Notice of Allowability

10/712,602

EXAMINER'S AMENDMENT

--Apparatus and Method for Removing Flooring Tile—

FIG. 1

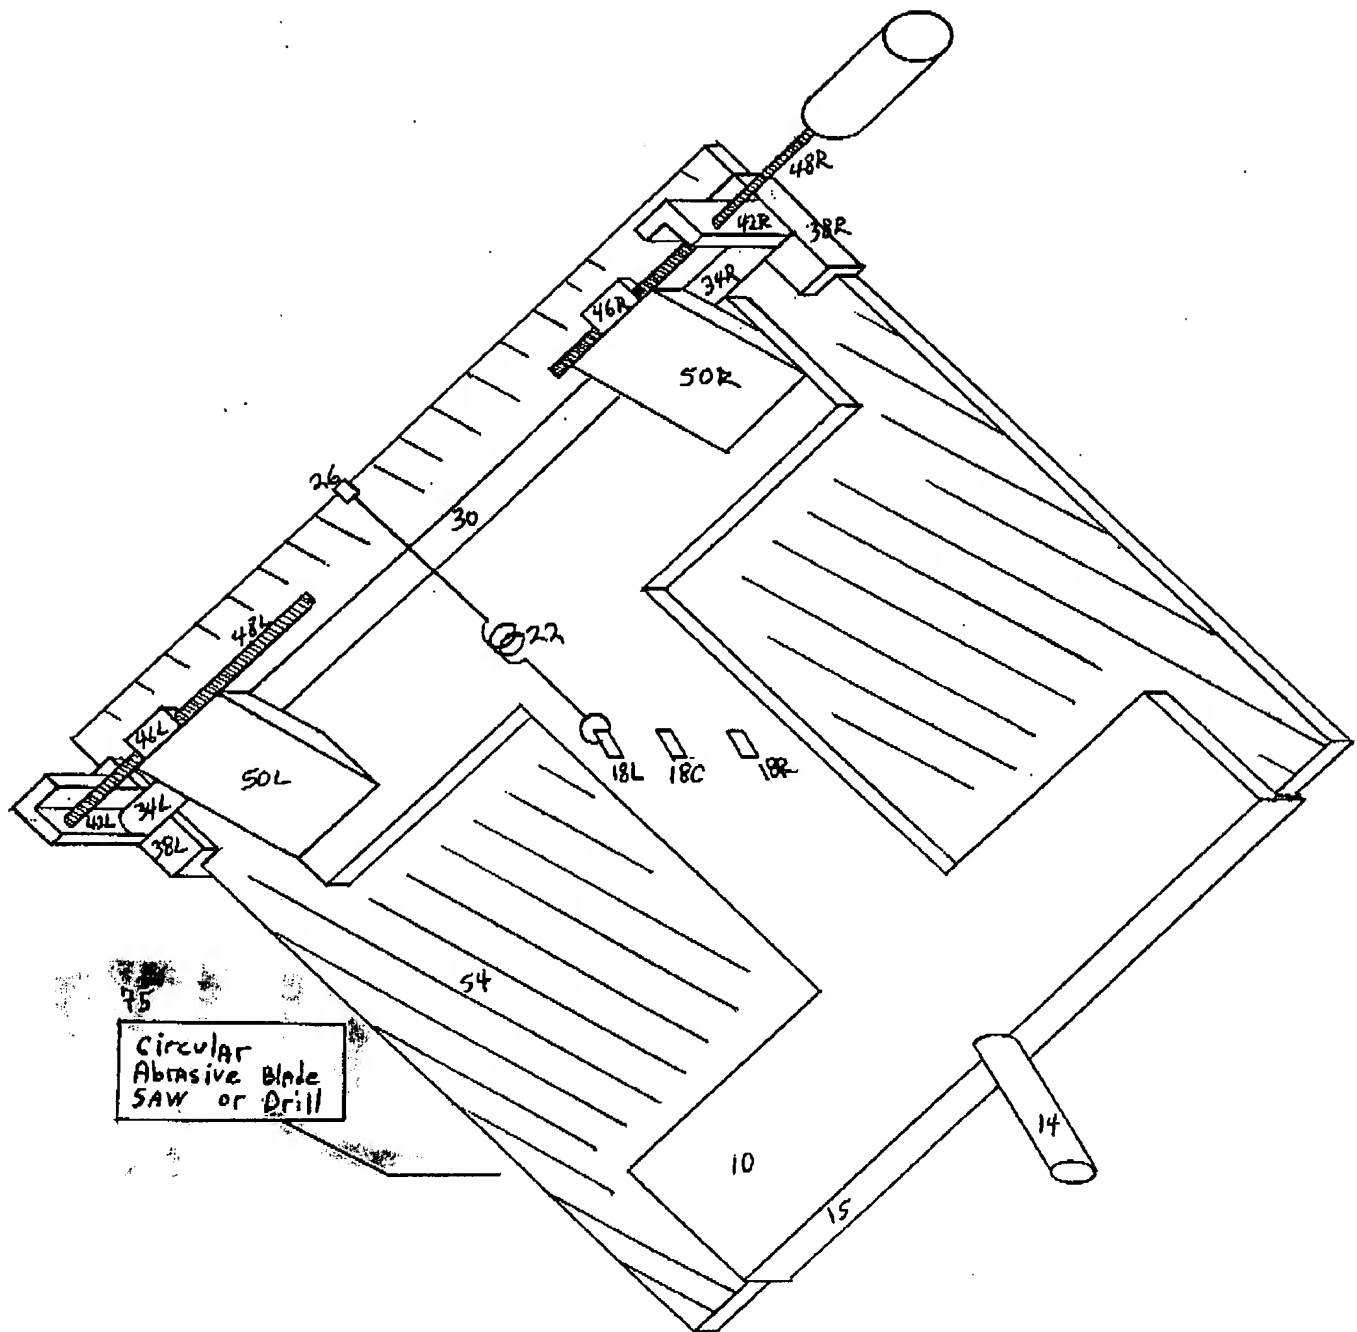
2. The following changes to the drawings have been approved by the examiner and agreed upon by applicant: in figure 1, a box has been added as shown on the following page. In order to avoid abandonment of the application, applicant must make these above agreed upon drawing changes.
